SAFETY ALERT SA0004

EFFECTIVE DATE: This Safety Alert is effective December 08, 2006
SUBJECT: Aft Control Stick
MODELS AFFECTED: CC11-100 S/N CC11-00002 thru CC11-00004.
COMPLIANCE TIME: Prior to Next Flight
PURPOSE: Aft Control Stick Replacement

Figure 1– Aft Control Stick

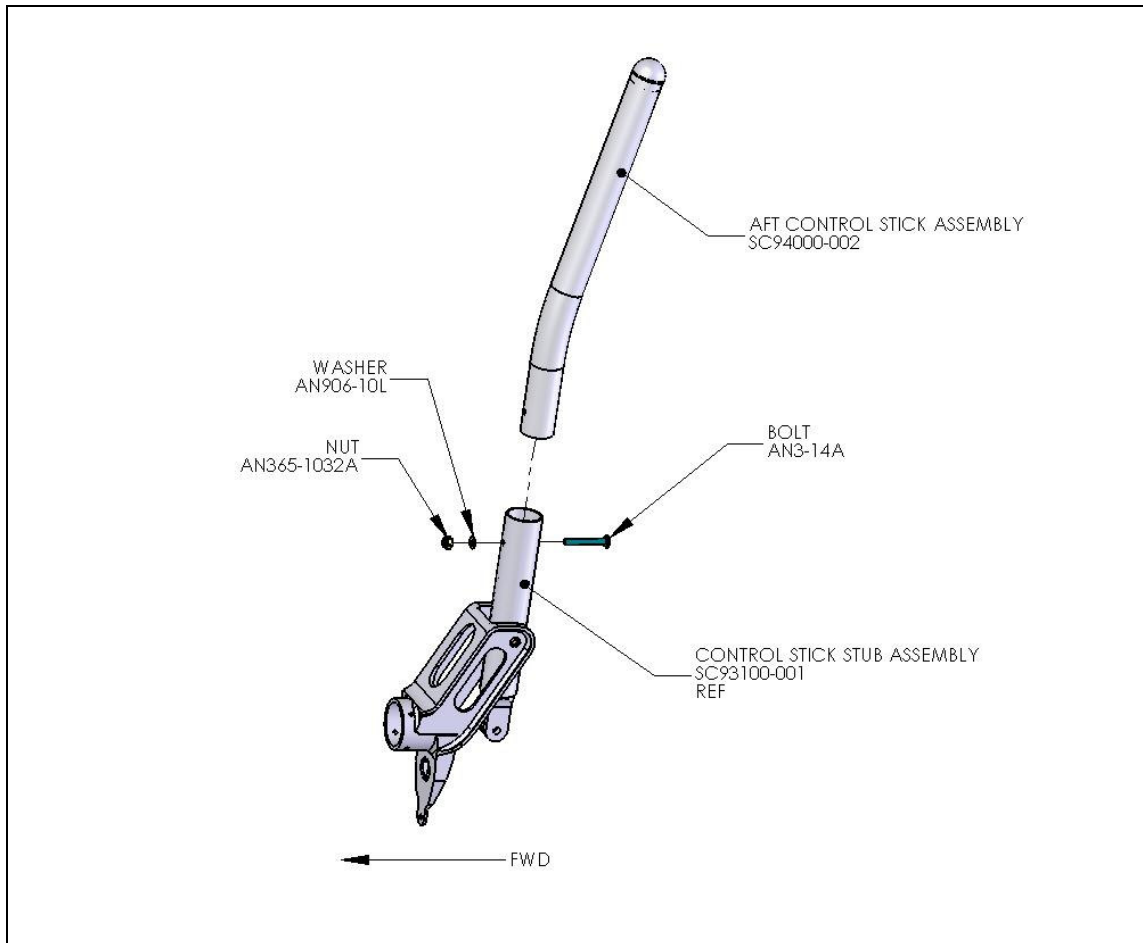
1. Remove bolt (AN3-14A), washer (AN960-10L), and lock nut (AN365-1032) from existing assembly.
2. Remove control stick assembly (SC94000-002) revision NC from control stick stub assembly (SC93100-001).
3. Discard control stick assembly (SC94000-002) revision NC (straight stick).
4. Place control stick assembly (SC94000-002) revision A (bent stick) into control stick stub assembly (SC93100-001) as shown in figure 1. Ensure bend is toward the aft end of the aircraft.
5. Replace bolt (AN3-14A), washer (AN960-10L), and lock nut (AN365-1032) as shown in figure 1.
